**Re: Shenkman/Cavanagh – Kanata West
195 Huntmar Community Transportation Study – Addendum #1**

Section 2 of this addendum addresses the comments received from the City of Ottawa, dated November 24, 2016 in order to complete the file.

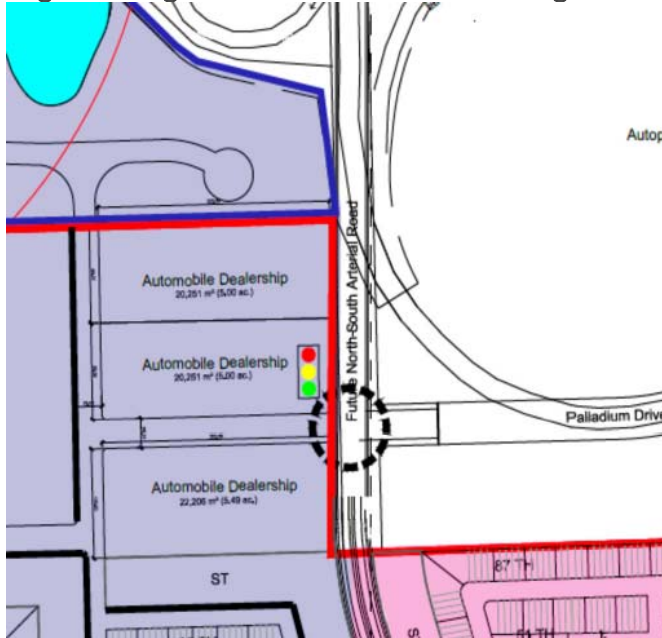
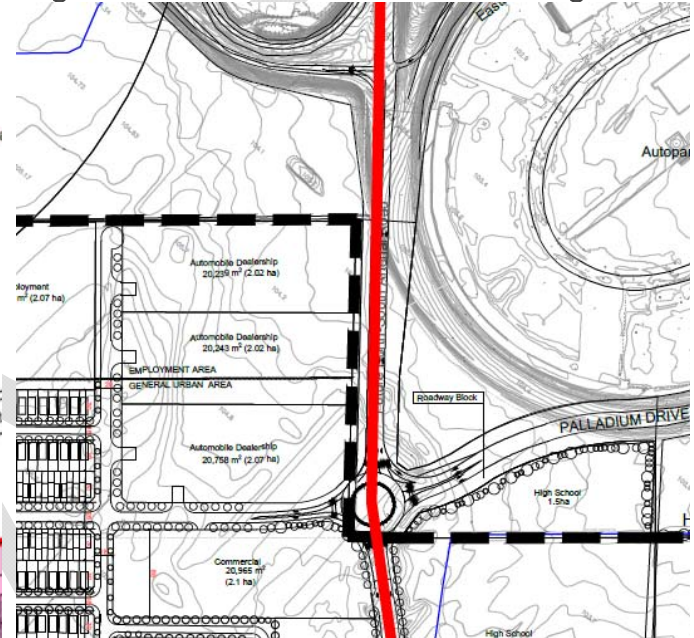
Within the original CTS, the location of the Palladium Drive extension to the North-South Arterial was proposed approximately 350m north of the planned North-South Arterial/Stittsville Main roundabout intersection and approximately 300m south of the HWY 417 eastbound off-ramp. Through consultation with the Ministry of Transportation of Ontario (MTO), we were advised that the location of the proposed Palladium Drive extension to North-South Arterial is too close to the HWY 417 eastbound off-ramp. Through further consultation with the project team, the City, and adjacent land owners, a revised location of the proposed Palladium Drive extension to North-South Arterial is proposed. The revised location is approximately 400 m south of the HWY 417 off-ramp and approximately 250 m north of the North-South Arterial/Stittsville Main intersection. The original proposed location and the revised location are shown as Figures 2 and 3, respectively.

The following revisions to the Palladium Drive Extension and North-South Arterial intersection are presented:

- The revised Palladium/N-S Arterial intersection is proposed to be a multi-lane roundabout;
- The intersection is located approximately 400 m south of the HWY 417 eastbound off ramp;
- The intersection is located approximately 250 m north of the proposed N-A Arterial/Stittsville Main intersection;
- To accommodate this alignment, the land south of the Palladium Drive extension has been acquired by the proponent and will be incorporated into the proposed development as part of the high school lands;
- This revised alignment improves east-west connectivity to the site by aligning Palladium Drive with the east-west collector roadway that continues through the site to Stittsville Main Street extension.
